Euro Jeans Ltd (New Shed)

Vogra, Chowdhury Bari, Gazipur
(23.978714, 90.379255)

07 September 2021

Observations

Provided Design Report

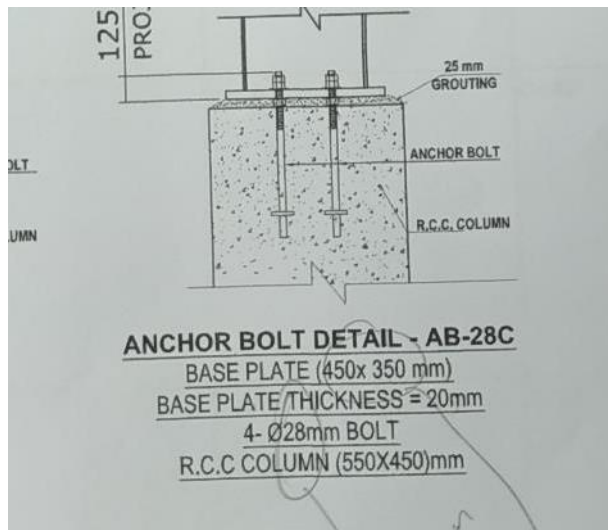
As per BNBC, every building or structure designed shall have its design documents prepared in accordance with the provision of Section 1.9.1. The design document shall include a design report, and a set of structural drawings, which shall be prepared in compliance with section 1.9.1.1 and section 1.9.1.2 of BNBC.

In provided design, the strength of steel plate have been considered 50 ksi and the compressive strength of concrete have been considered 3000 psi. No credible test report has been found regarding that values. On the other hand, no analysis has been carried out for RC Part of the structure. Factory is required to submit the full set of Design Report with necessary corrections.

Inconstancies in the drawings

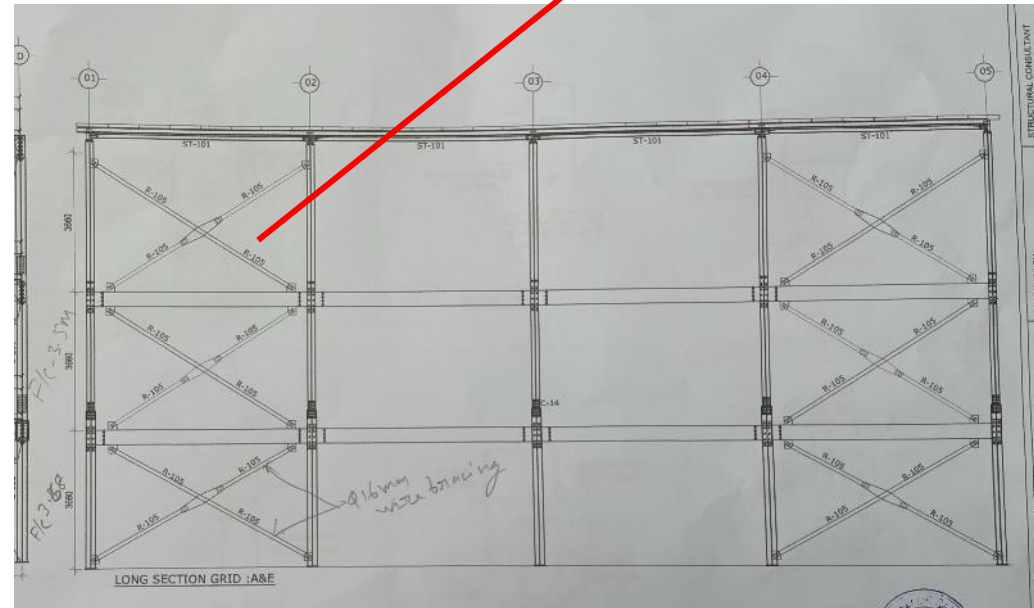
Base plate of AB-28C was found 400mm X 300mm instead of 450mm X 350mm

16 mm Cable bracings were found in as-built condition whereas drawing shows box bracings

Pile Cap Layout

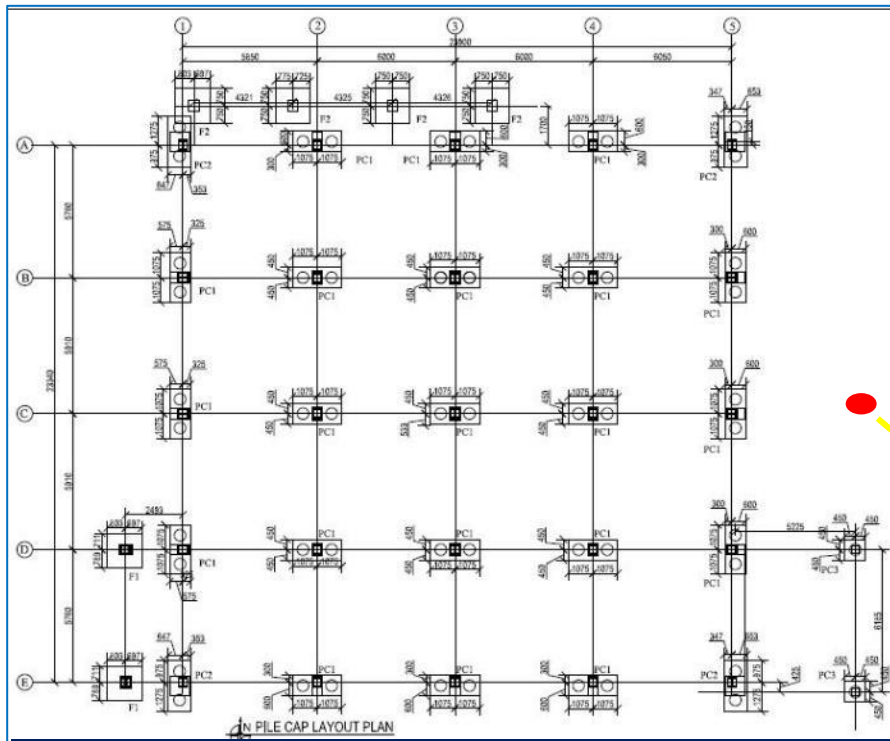
Marked column did not shown in drawings. Also, foundation of the column is unknown.

Circular column at front

Water tanks

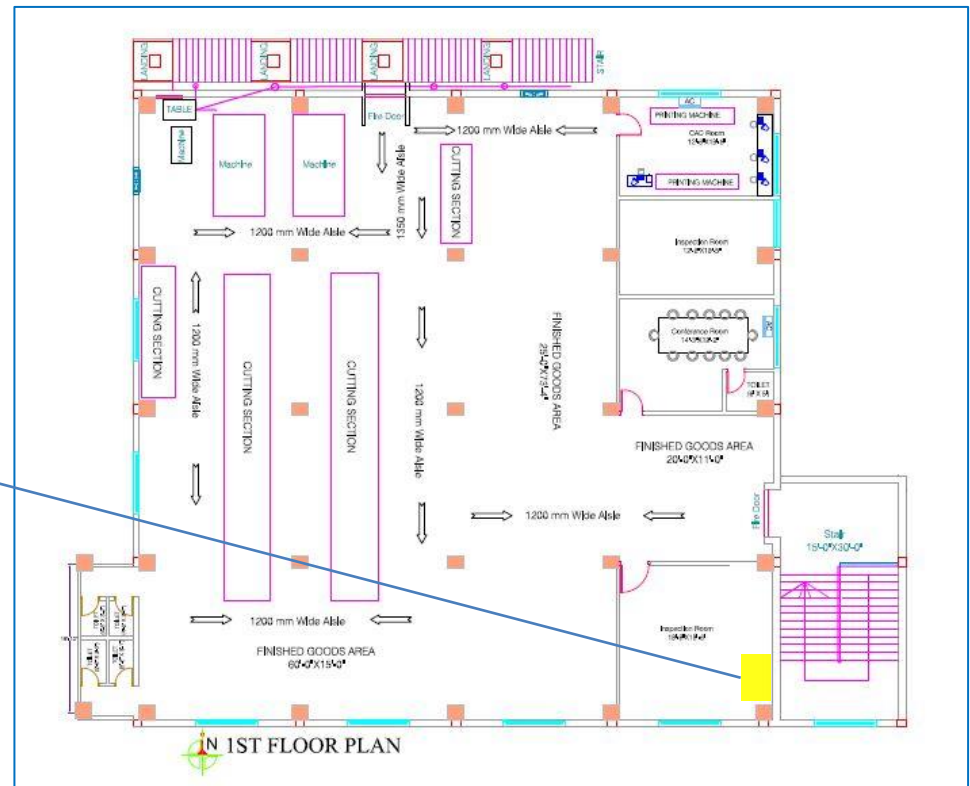
Plastic water tanks on stair top not shown in drawing. Also, toilet zone was found different with drawings.

Toilet zone of 1st floor
Not shown in drawings

Significant connection gap

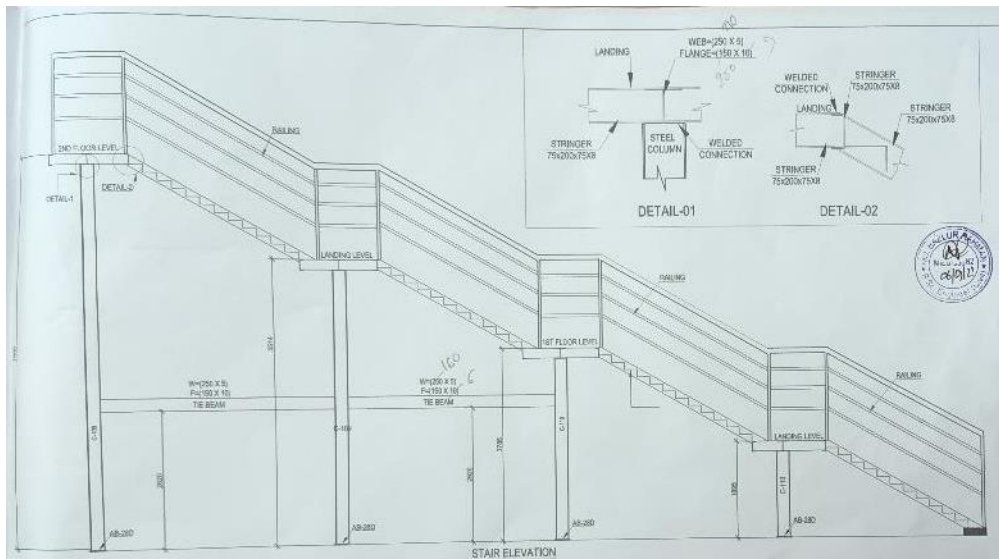
Gap observed in Beam- Column connection

Significant gaps observed at column-beam joint at several locations. Factory engineer is required to carry out suitable remedial works.

08	Significant connection gap. (Shed-3)	Identify the locations of connection gaps and carryout suitable repair works where necessary.	6-weeks

Support System of Steel Stair

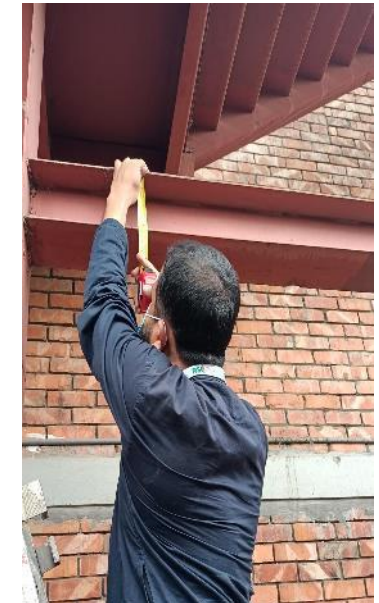
The sizes of steel tie beam and landing joist are not matched with drawings. Web of landing joist was measured 210 mm instead of 250 mm. Flange thickness of tie beam was found 6 mm whereas drawing shows 10 mm. Also, the web of tie beam was measured 160 mm instead of 250 mm

External steel stair is standing on single grid column. There is no visible lateral stability system. Factory engineer is required to carry out connection adequacy & lateral stability check of the steel stair.

Item No.	Observation	Recommended Action Plan	Recommended Timeline
09	Mismatch in drawing. (Shed-3, External Steel Stair)	The building engineer to survey the structure and update the as-built drawings accordingly.	6-weeks
10	Lateral Stability. (Shed-3, External Steel Stair)	The building engineer is required to carry out connection adequacy & lateral stability check of the steel stair.	6-weeks
11	Lateral Stability. (Shed-3, External Steel Stair)	Implement remediation work where necessary.	6-months
12	Undocumented Structures (Jhut Store & Compressor Room).	Factory engineer is required to produce as-built drawing reflecting the as constructed condition.	6-weeks
